Lake City Community Center

February 19, 2026 | 9:30am – 11:00pm | Final Approval

At this meeting the project team will present responses to the twelve recommendations from the Design Commission’s first meeting on September 4, 2025. The presentation addresses entry design, park integration, circulation, cultural art, bike infrastructure, landscape, coordination with adjacent uses, and microgrid opportunities. Barring major issues, this is the Commission’s final full review of this project. The Commission should evaluate whether the design revisions adequately address the prior recommendations and identify areas requiring further development.

Design Commission Meeting #1 Recommendations

Group 2: Simplified Circulation and Park Integration (Recommendations #3, #4)

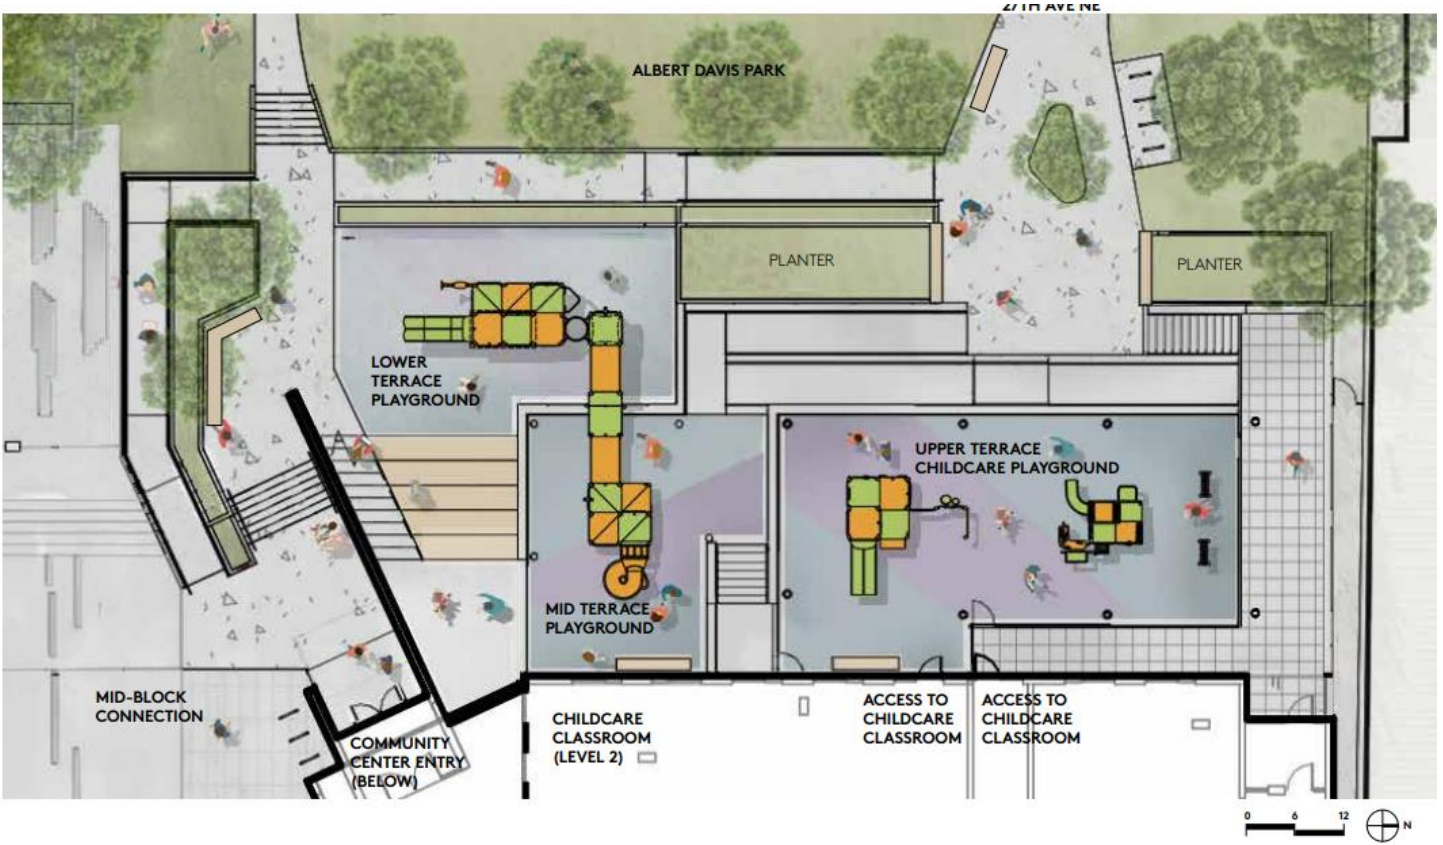
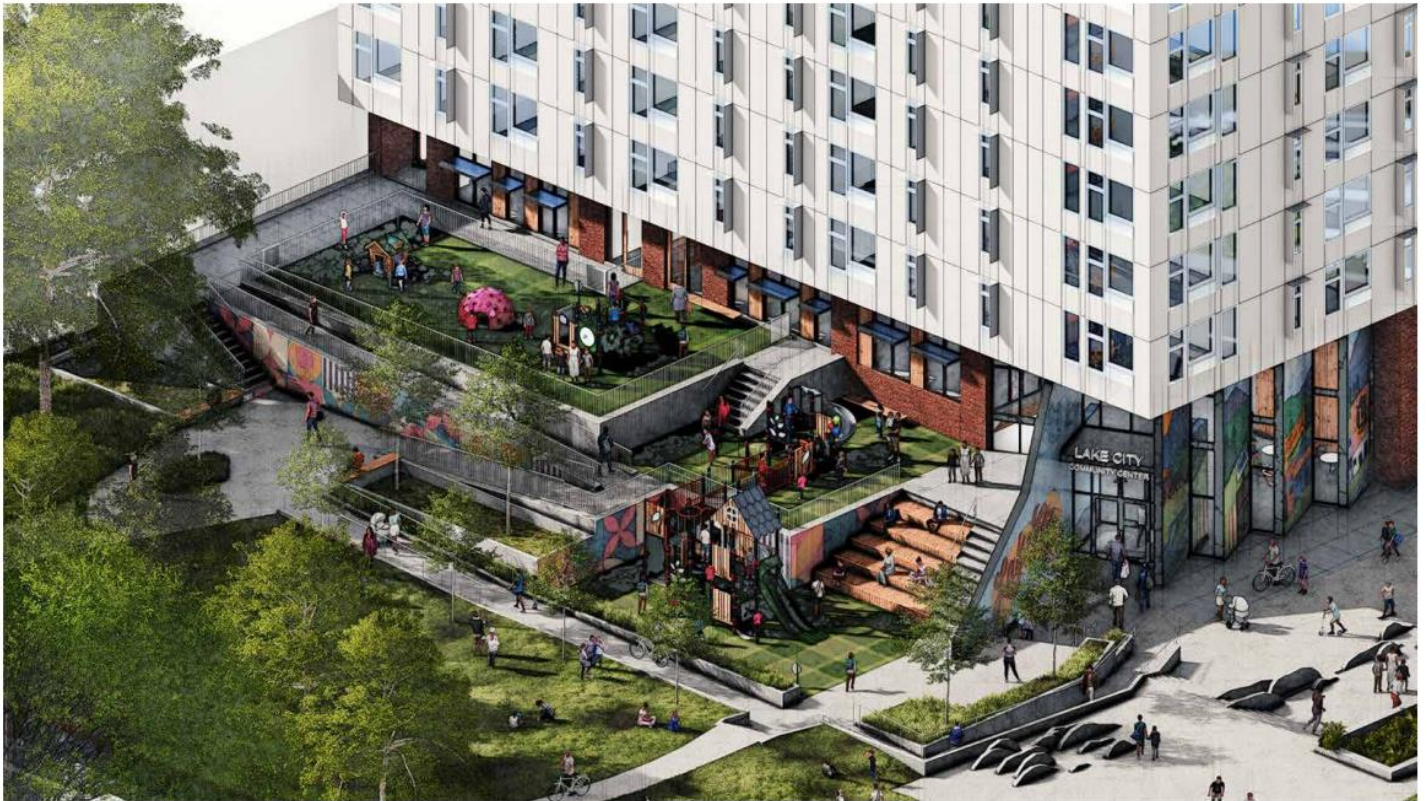
To simplify circulation (Recommendation #3), the design team has reduced ramp complexity on the side of the building connecting the community center to Albert Davis Park and improved wayfinding. The previous design involved multiple ramp turns; the revised design uses straighter paths with planters defining zones between levels.

To improve integration with the park (Recommendation #4), the playground has been relocated closer to Albert Davis Park using a three-tiered terrace system: a lower terrace playground adjacent to the park, a mid terrace playground, and an upper terrace childcare playground. This arrangement brings the play areas into closer proximity with the park.
